240-208V 3ø 1HP - 20HP VARIABLE FREQUENCY DRIVE ELECTRICAL STANDARD - ALTERNATE

EMERALD COAST UTILITIES AUTHORITY
ESCAMBIA COUNTY, FL

LIFT STATION CONSTRUCTION DETAILS

ELECTRICAL STANDARDS

Drawn:	
Designed:	
Checked:	
Date:	PROTOTYPE
Scale:	
Project No:	
Sheet No.	5
Of	17 Sheets

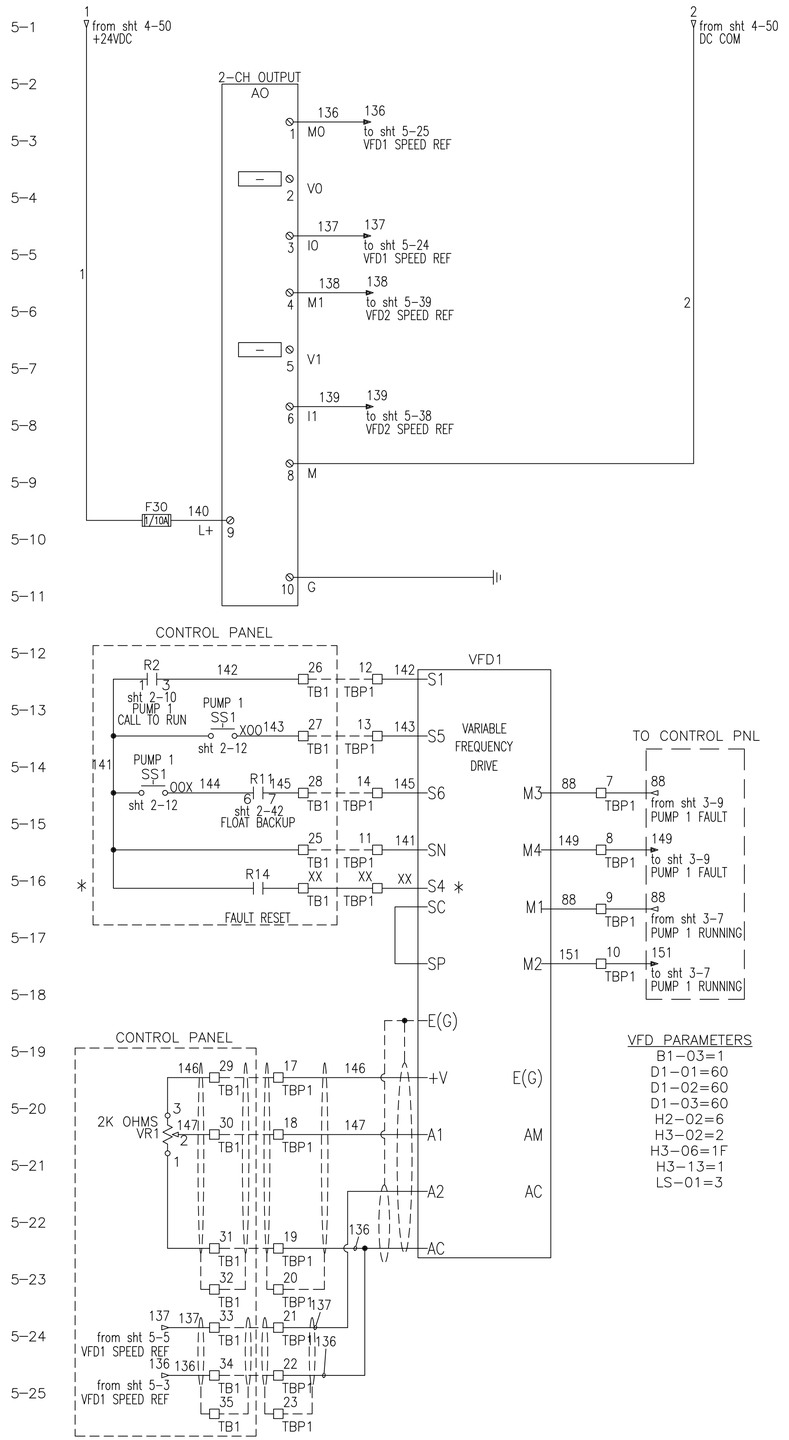
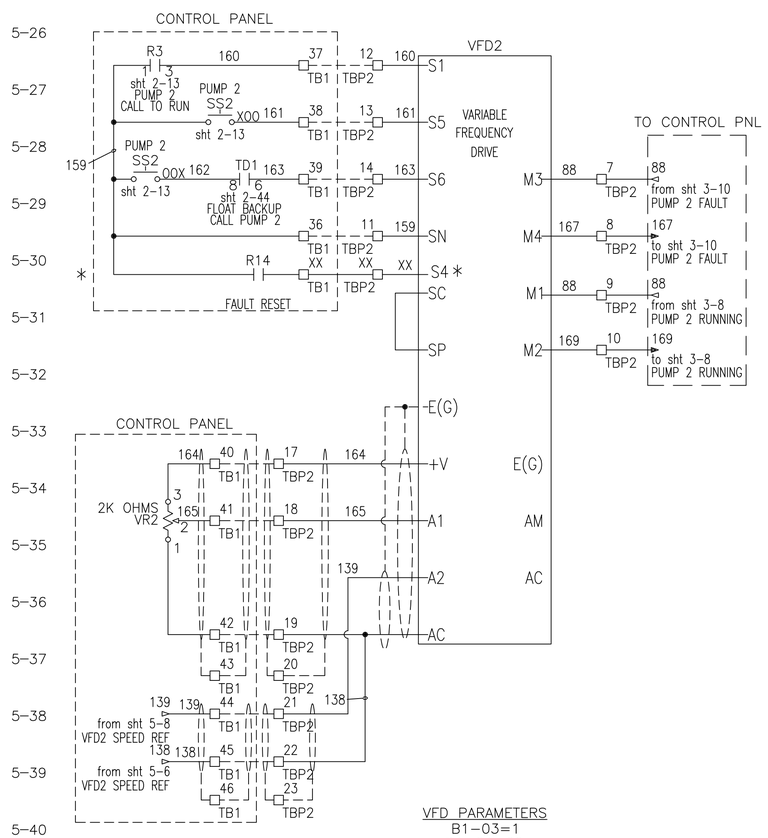
* CONNECTION AT S4 WAS ADDED AND NEEDS TO BE INTEGRATED INTO TERMINAL BLOCK.
